CABINET MEMBER FOR ENVIRONMENT – 27 JUNE 2019

DIDCOT: B4493 WANTAGE ROAD ROUNDABOUT JUNCTION WITH FOXHALL ROAD – PROPOSED SHARED USE CYCLE TRACK

Report by Director for Community Operations

Drawing title
**DIDCOT
 BETWEEN B4493 WANTAGE ROAD
 AND B4493 FOXHALL ROAD**

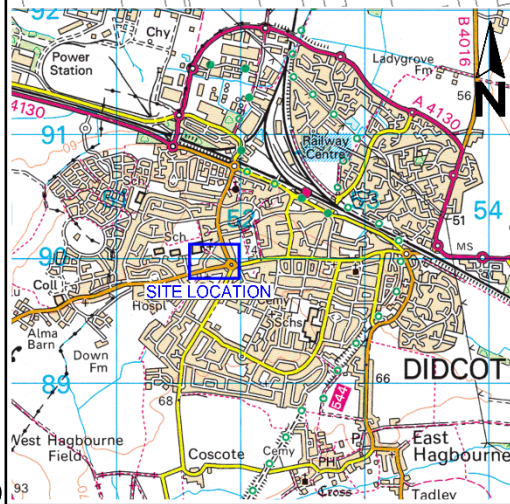
RESPONDENT	SUMMARISED COMMENTS
(1) Traffic Management Officer, (Thames Valley Police)	No objection
(2) Didcot Town Council	Support with concerns - Didcot Town Council supports the proposed shared-use cycle track in principle. The main areas of concern are over trees lowering visibility as cyclists join Foxhall Road and parked cars doing the same as bikes cross Glyn Avenue. Didcot Town Council asks that appropriate measures be put in place to reduce the risk of accidents in these areas.

(3) Local Group, (Harwell)	<p>Object - Whilst HarBUG (Harwell Campus Bicycle Users Group) support the building of cycle infrastructure in Didcot we feel that this particular proposal will not achieve satisfactory results for the following reasons:</p> <ul style="list-style-type: none"> - Any cyclists wishing to turn left at Foxhall Roundabout will already have turned left down Manor Crescent to avoid the roundabout and take the shortest route. Manor Crescent also provides a link to Lydalls Close and Lydalls Road to Didcot Parkway, this route should be improved to provide a direct Didcot Parkway to Harwell Campus route (taking the Girl's School in route). - Many cyclists would like to continue down the Broadway but avoid the roundabout so a shared use path to connect to the pedestrian crossing would be a more useful proposition, changing the pedestrian crossing to a 'Tiger' crossing. This would also meet the aims of the Didcot Garden Town project to create a cycle route down the full length of the Broadway. <p>HarBUG feel that the limited funds available for cycle infrastructure could be better focussed for the Foxhall Roundabout and would advocate a change of design to allow cyclists a safe crossing to continue down the Broadway and improve Manor Crescent and it's junction with Wantage Road and Foxhall Road to Lydalls Close.</p>

<p>(4) Local Resident, (Didcot)</p>	<p>Object - on the ground of health and safety and money saving aspect. The proposed path is actually not used by bikes at the moment. Cyclist from Wantage Road going down to Foxhall Road are probably using Manor Cress as a short cut. The path will not bring any advantages to there. Cyclist going uphill from Foxhall Road to Wantage Road will have to cross the road. This is probably more dangerous than going around the roundabout. Cyclists in the morning are usually young boys in direction of the boy school via the Glyn avenue. The path will not bring any advantages. In case, you still decide to put the cycle path in Foxhall road, a set of trees and a small building is actually blocking the view. Cars will not be able to see oncoming cyclists. In that case, a crossing will have to be implemented. Foxhall road has already two crossings (one with traffic lights and the other a zebra crossing) within a short distance of each other. This is not a suitable proposition to have multiple crossing so close to each other. To summarise, the cycle path is not going to bring any additional value to the community and is actually dangerous in the design. This is going to increase the risk of accidents. Thanks for considering my opinion.</p>

<p>(6) Local Resident, (Didcot)</p>	<p>Object - In my opinion, a waste of time, effort and more importantly, money. That's hardly a cycle track but a mere cut-through. If you want to make things better for residents a much larger cycle network around the town would be very welcome. All this proposed work will not make any real difference to safety as it's too little.</p>
<p>(7) Local Resident, (Didcot)</p>	<p>Object - I walk my dog along this route on a daily basis. The junction of the footpath and the cut-through at Wantage Road is obscured by large, privately owned hedges I assume. If a cyclist is coming from the Foxhall Road direction, they will have difficulty seeing if the footpath is clear. As it stands, I or my dog currently "bump" into people 2-3 times a week</p>

<p>with people going in the opposite direction. In order to provide a better view for cyclists, you would have to put the cycle section on the side furthest from the hedge in order to provide anything resembling a clear view.</p> <p>How are you going to ensure that the footpath junction at the Wantage Road end is safe for both pedestrians, animals and cyclists?</p> <p>To this end, how will you improve visibility so people can see whether another user is heading their way from around the corner?</p> <p>How will you ensure people stay in their lanes to ensure no corner cutting with possible accidents?</p> <p>How will you limit cyclists speed?</p> <p>How will you ensure that cyclists will stop and check clearance at the junction at Wantage Road to allow pedestrians to continue down the road safely? Cyclists already cycling along the main footpath of Wantage Road on the same side and are not always mindful of pedestrian users of the footpath.</p> <p>How will you ensure that the hedges bordering the current footpath remain cutback/maintained so the footpath is not reduced?</p> <p>If you are removing the current stand of trees, will you be replacing the planting with other appropriate planting?</p> <p>If you can address the safety issues raised, then I would be more likely to support the proposal.</p>

<p>Money would be better spent put towards better and more useful cycling infrastructure. A single short section is of no help at all.</p>
<p>(10) Local Resident, (Didcot)</p>	<p>Object - My front gate would go straight out onto the proposed track and we have had near misses from bikes with the grandchildren , also the amount of bikes that we have now probably doesn't warrant the money you are prepared to pay for the track it could be better used repairing Glyn Avenue and getting the lorries and cars removed from the turning circle so that the rubbish bins are emptied on a regular basis.</p>
<p>(11) Local Resident, (Harwell)</p>	<p>Object - I cycle this daily from Harwell to Didcot Train station, I see no value at all in this improvement, and if implement unlikely to use it.</p> <p>Money better spent on improving the quality of the roads.</p>
<p>(12) Local Resident, (Didcot)</p>	<p>Object - There is no point making this short section a cycle path. It does not connect anything to anywhere. Cyclists are safer on the road using the roundabout correctly.</p> <p>From a safety point if view, the vegetation would need to be cleared on the Foxhall road side to prevent a blind corner and pedestrians being run down by cyclists</p> <p>.</p>

<p>Detailed design points, working from North to South:</p> <p>A painted cycle sign in the Foxhall Road carriageway southbound just before the turn may help cyclists turning right into the new link.</p> <p>The use of a protected exit on to Foxhall Road is excellent.</p> <p>If the upgraded width can be extended to 3.5m, that can make it easier for cyclists to pass two pedestrians walking side-by-side (according to Patrick Lingwood, OCC).</p> <p>At the Wantage Road end, the narrowing of the shared route is odd. If there is a cyclist coming South on the upgraded path, waiting to head West and one coming East wanting to turn North that could be a problem. Better to keep the full 3-3.5m width?</p> <p>Also the Cambridge kerbs on both sides should be fully dropped to allow the cyclist heading South then West to cross the road and join the stepped route on the other side.</p>

(18) Local Resident, (Abingdon)	<p>Support - No comment</p>
(19) Local Group, (Oxford)	<p>Support - Suggest widening the shared path to a minimum 3.5m or 4m depending on available space in the verge. This should help future proof for higher volumes after new housing is built and make the path more comfortable for users.</p>

| | <ul style="list-style-type: none">- Disused children crossing warning sign, next to the telegraph pole. What will happen to this?-Relocation of telegraph pole requires movement of telephone cable to my property and possibly electrics. Will this cause much disruption?

-3M width for the shared use cycle track is too large and will be disproportionately large compared to the rest of the cycle path along Wantage road, making it look unsightly. This should be reduced to fit better with the environment.-Final point (Important!) Whilst being pro-cycling I don't understand the point of this cycle path? As it is not joining up to anything on Foxhall road so provides no net benefit to people. More to the point if a cyclist travelling east wanted to connect with Foxhall road they would just cycle down Manor Crescent instead and link up that way. Money on this scheme would be much better spent extending the cycle link into the centre of Didcot along Broadway and introducing traffic calming measures (slowing down cars) near the roundabout with functioning speed camera's, to make it safer for people to cycle |

12. An independent road safety assessment of the proposal has been carried out and it is proposed to cut back the hedges adjacent to the highway boundary to

ensure adequate visibility but otherwise no additional works were identified for the scheme to operate with acceptable safety. The suggestions for further improvements are noted but there are currently no funds to progress these.
